MORTON SUBDIVISION, RESUBDIVISION OF LOTS 1 & 2 OF THE RESUBDIVISION OF LOT 1

Engineering Comments: FINAL PLAT COMMENTS (should be addressed prior to submitting the FINAL PLAT for review and/or signature by the City Engineer):

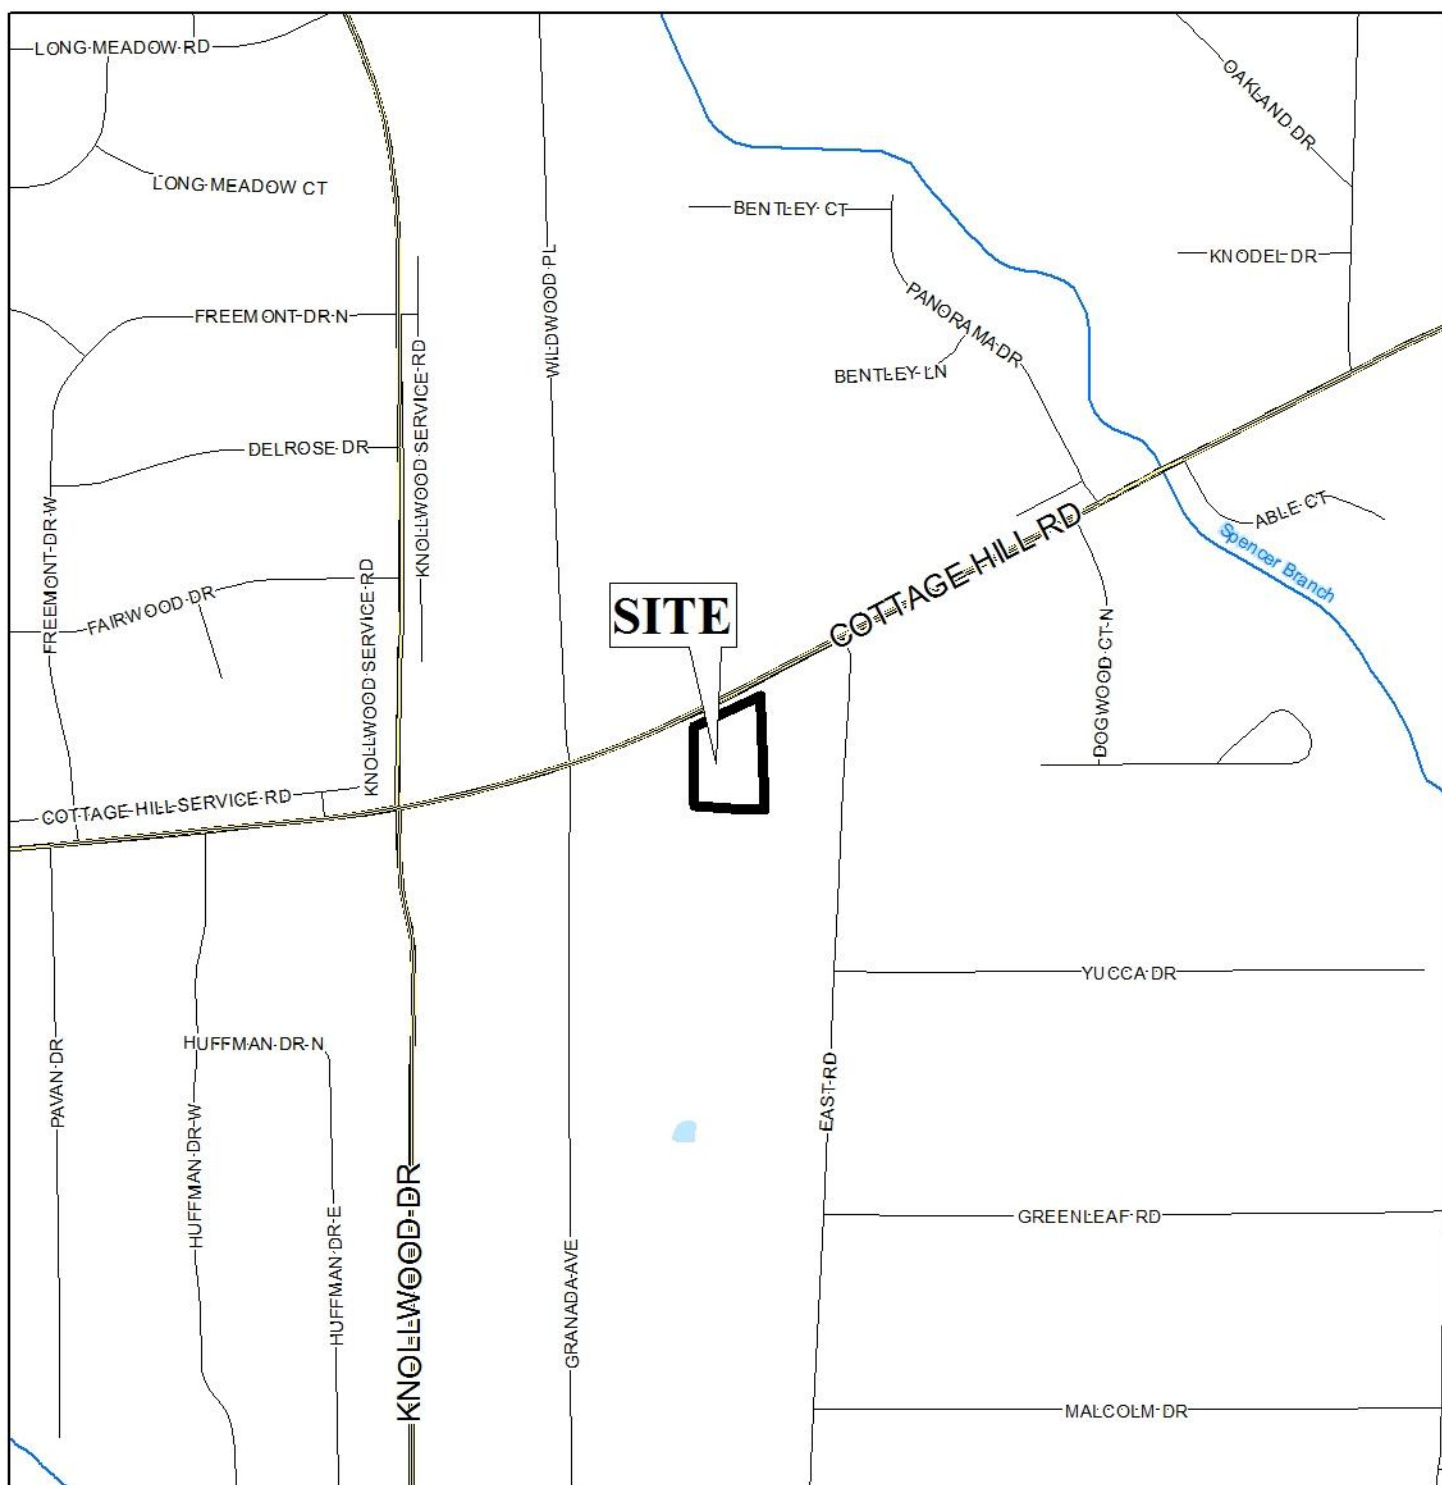
The site has frontage on Cottage Hill Road, a component of the Major Street Plan with a planned 100' right-of-way. The preliminary plat indicates that the right-of-way width of Cottage Hill Road varies; however, the existing recorded plat (Morton Subdivision, Resubdivision of Lot 1) depicts a sufficient 50' right-of-way from the centerline of Cottage Hill Road. Therefore, if approved the Final Plat should be revised to reflect the planned 100' right-of-way width of Cottage Hill Road.

As on the preliminary plat, the lot size label should be retained in both square feet and acres on the Final Plat, or a table should be furnished on the Final Plat providing the same information. No easements are indicated on the preliminary plat. If any easements are recorded on the site they should be indicated and labeled on the Final Plat, and a note should be placed on the Final Plat stating that no structure may be placed or constructed within any easement.

- 1) revision of the plat to illustrate the 100' right-of-way width of Cottage Hill Road;
- 2) retention of the plat to illustrate the 25' minimum building setback line along Cottage Hill Road;

- 3) retention of the lot size in both square feet and acres, or the furnishing of a table on the Final Plat providing the same information;
- 4) placement of a note on the Final Plat stating that no structure may be constructed or placed within any easement (if applicable);
